|  DEVELOPMENT ASSESSMENT REPORT | | | | |
| Application No. | REV/2021/0006 | | | |
| Address | 95 Ramsay Street HABERFIELD NSW 2045 | | | |
| Proposal | S8.2 Review Application to MOD/2020/0401 for modification of existing development to regularise works and inclusion of a dogwash facility | | | |

Figure 3: Proposed signage location.

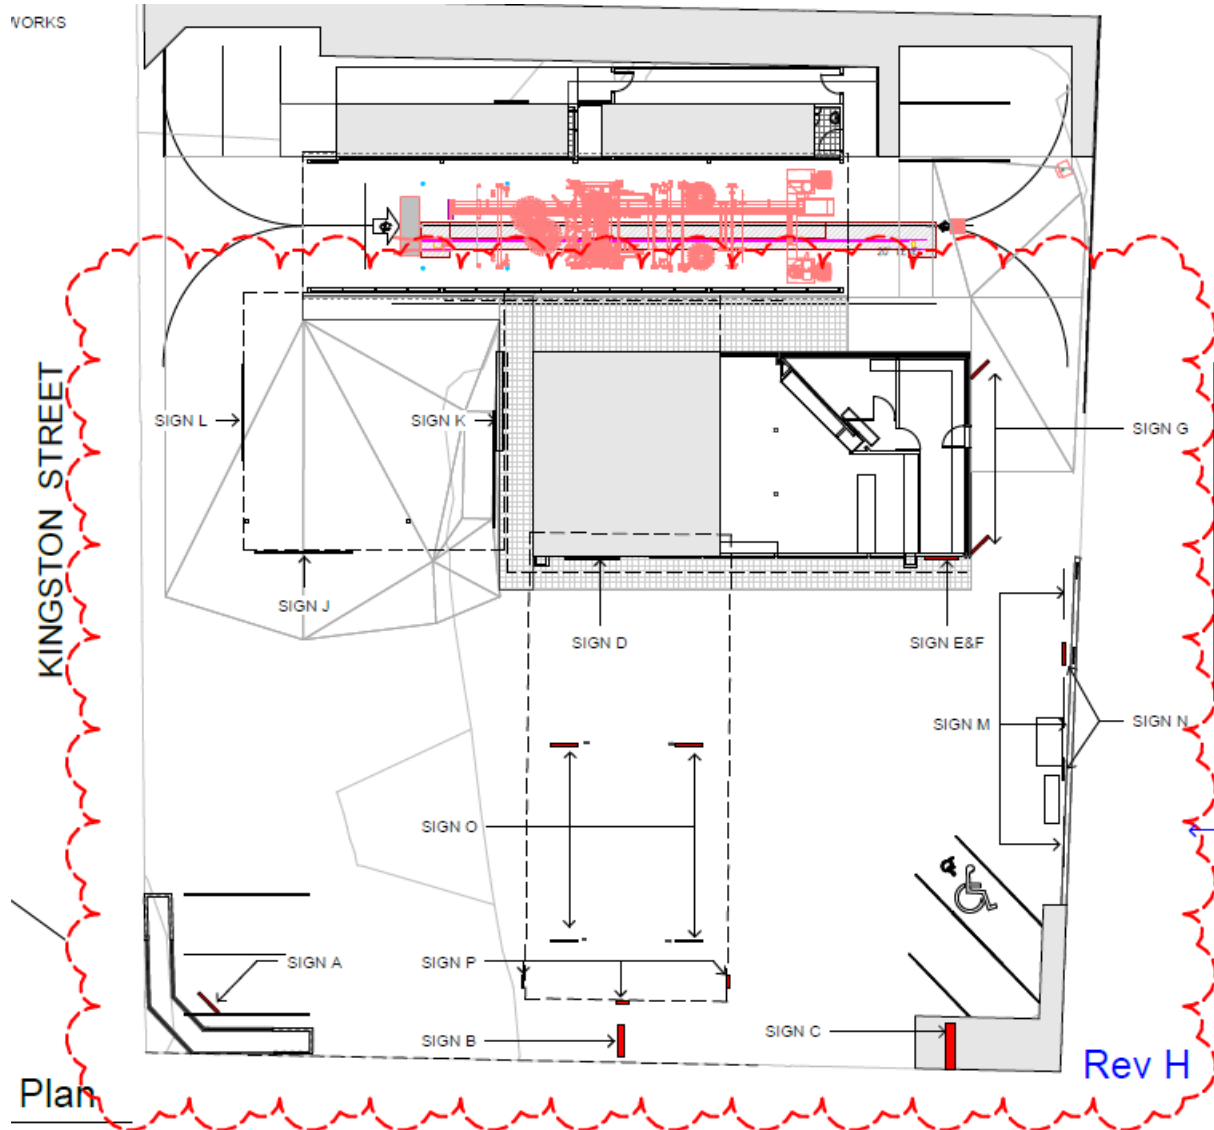
While in principle new signage can generally be supported on the site, the proposed signage schedule is not considered to satisfy the assessment criteria contained in Schedule 1 of SEPP 64. The signage proposed is considered inconsistent with the existing character of the area and the streetscape and detracts from the visual quality and amenity of the Haberfield Heritage Conservation Area and the adjoining residential uses. The extent of signage proposed is considered unnecessary and results in visual clutter given the total number of signs on the site and their proximity and positioning relative to other similar signs, particularly along the southern boundary.

In addition to the above, the submitted plans demonstrate that Sign A obstructs the two proposed parking spaces at the western corner of the site. While not shown on the plans, an existing air pump is also located adjacent to Sign A, further reducing the space available for car parking.

- a) *Sign A and the adjacent air pump as indicated on the approved plans be deleted.*
- b) *Signs I, L, and J as indicated on the approved plans be deleted.*
- c) *Sign M as indicated on the approved plans be amended to be one (1) sign only.*
- d) *Sign N as indicated on the approved plans be amended to one (1) sign only.*

Figure 4: Proposed car parking plan indicating seven (7) car parking spaces.

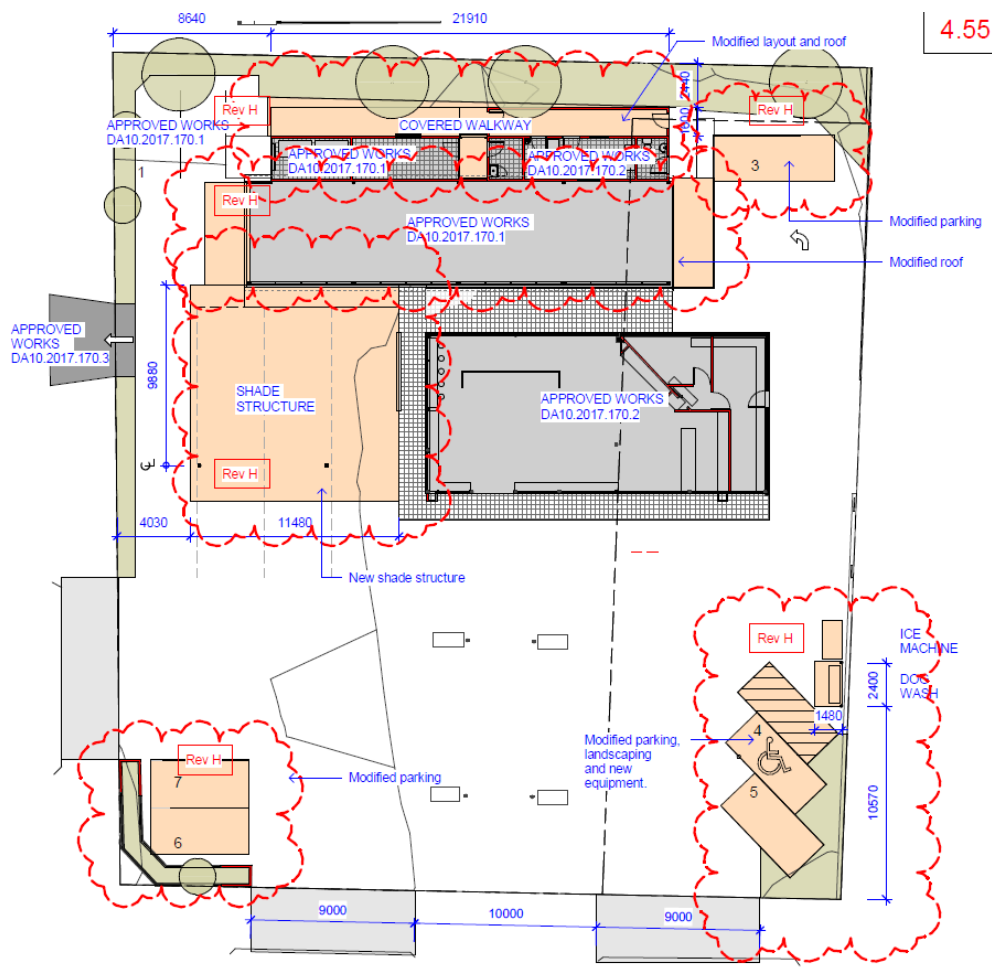
Part 8 of IWCDCP 2016 requires a minimum of eight (8) car parking spaces to be provided for the service station and convenience store. The existing development consent for the site requires a minimum of nine (9) parking spaces. The application proposes to reduce the number of parking spaces to seven (7), as demonstrated in Figure 4 below.

The proposed reduction is a result of previous acoustic mitigation works being undertaken on the site resulting in insufficient space in the eastern rear corner of the site to accommodate the approved three (3) parking spaces. Notwithstanding, it is considered that there is sufficient area on the site to accommodate one (1) additional space to provide the eight (8) car parking spaces required to satisfy IWCDCP 2016.

Subject to the imposition of a condition requiring the removal of Sign A and the adjacent air pump, a reduction in the width of the adjoining driveway crossing on Kingston Street from the current width of 10 metres down to 7 metres, this will provide sufficient area in the western corner of the site to accommodate three (3) parking spaces as previously approved. Therefore, the provision of an additional space in the western corner enables the eight (8) required spaces to be provided. The reduction in driveway width does not compromise ingress and egress from the site and ensures the development can comply with the prescribed parking requirements.

Figure 5: Approved site plan (DA 2017.170.3) demonstrating nine (9) car parking spaces.

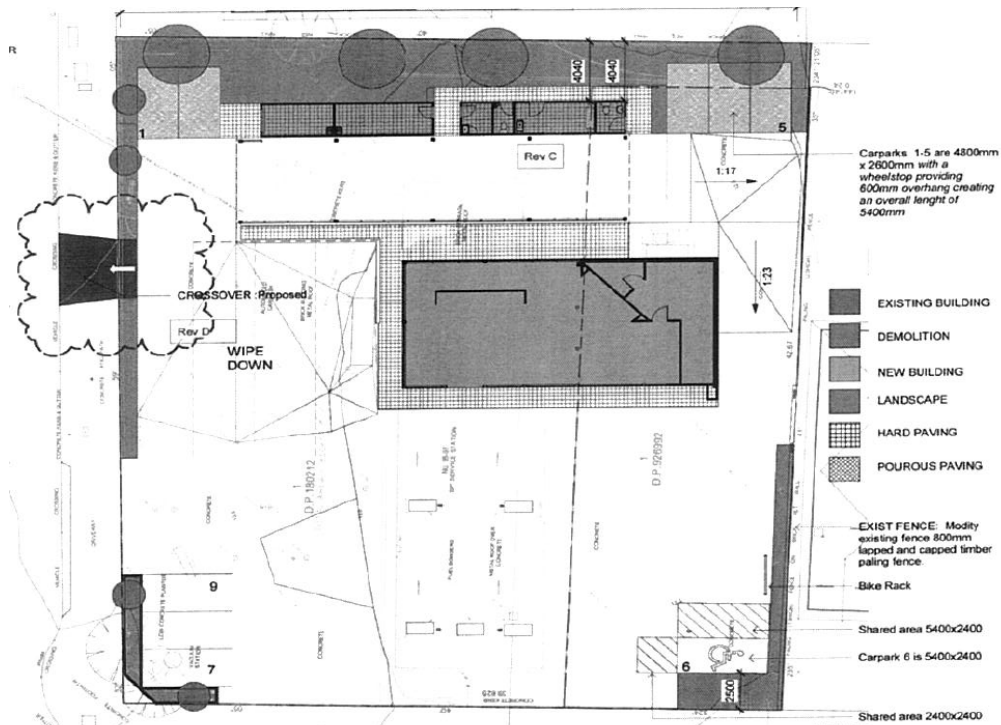
As demonstrated in Figure 5 below, the development was previously approved with nine (9) parking spaces, three (3) of which were to be provided at the western corner of the site. It is

noted that the parking arrangement and landscaping strip have not been constructed in accordance with the approval. The angle and extent of the landscape buffer differ, the placement of trees do not match and the space is currently obstructed by Sign A and an air pump.
